SINGAPOREAN NOTICES TO MARINERS

**SECTION II
SINGAPORE NOTICES**

3129*/02 SINGAPORE STRAIT – Singapore – Jurong Island, East Coast – Jetties: Depths: Works: Light

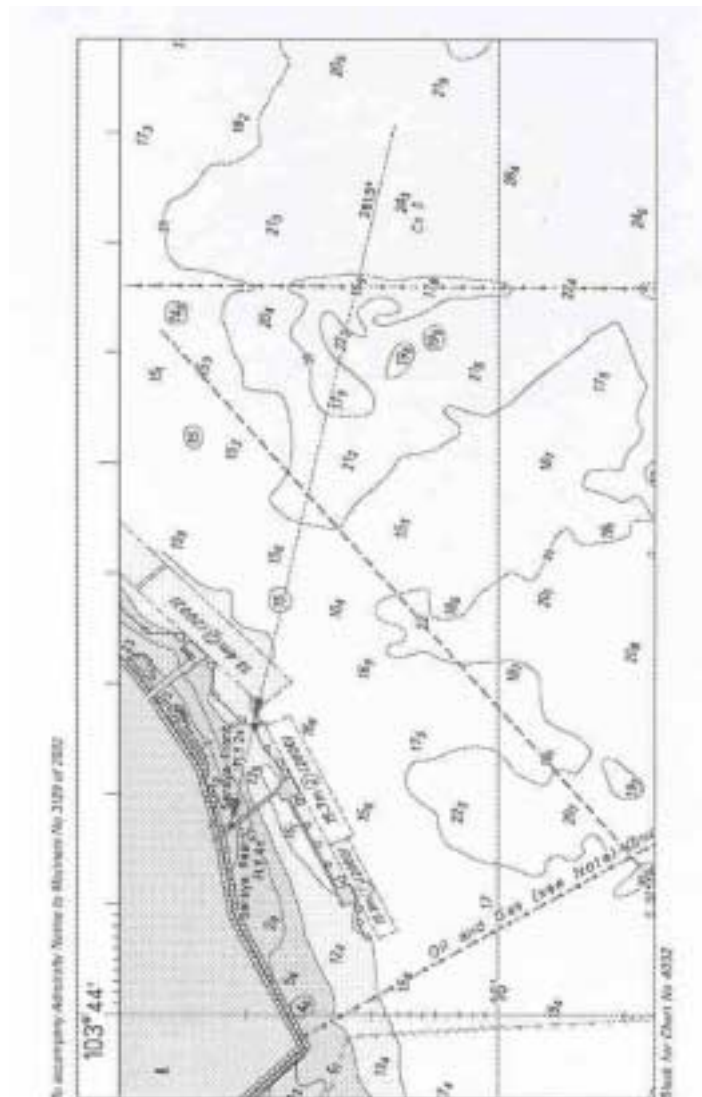
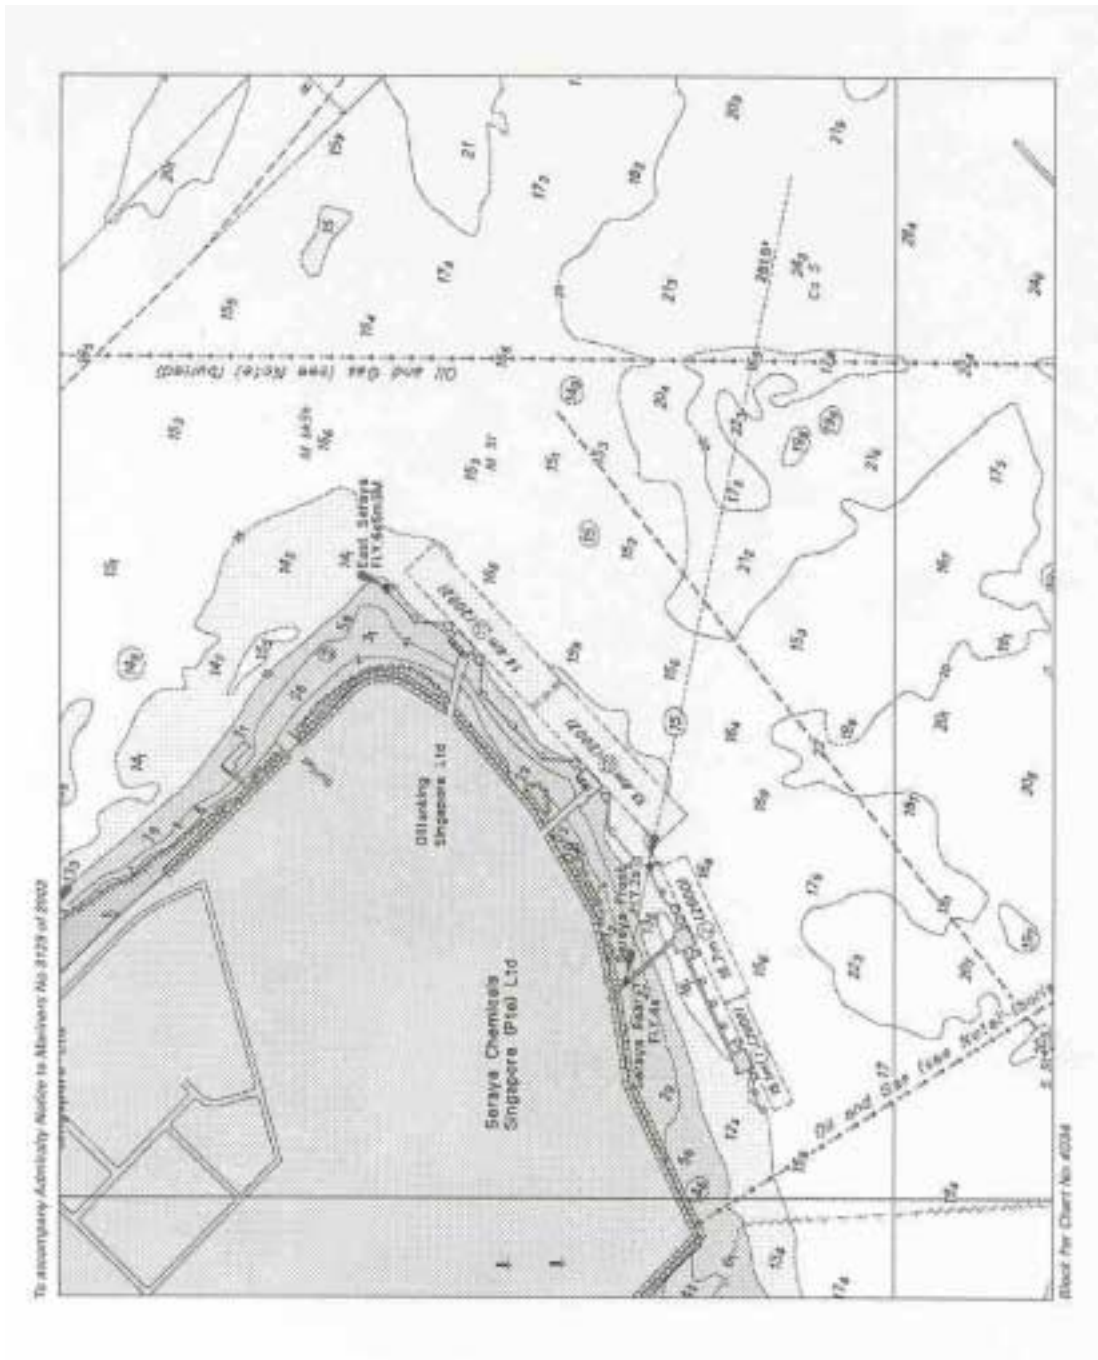
Insert	the accompanying block, showing amendments to jetties, and depths and works area, centred on:	(a) 1°16'.103N.,	103°44'.405E.
	the accompanying block, showing amendments to jetties, and depths and works area, centred on:	(a) 1°16'.267N.,	103°44'.405E.

Chart [*Last correction*]. – **4032** (a) [3068/02] – **4034** (b) [3070/02]
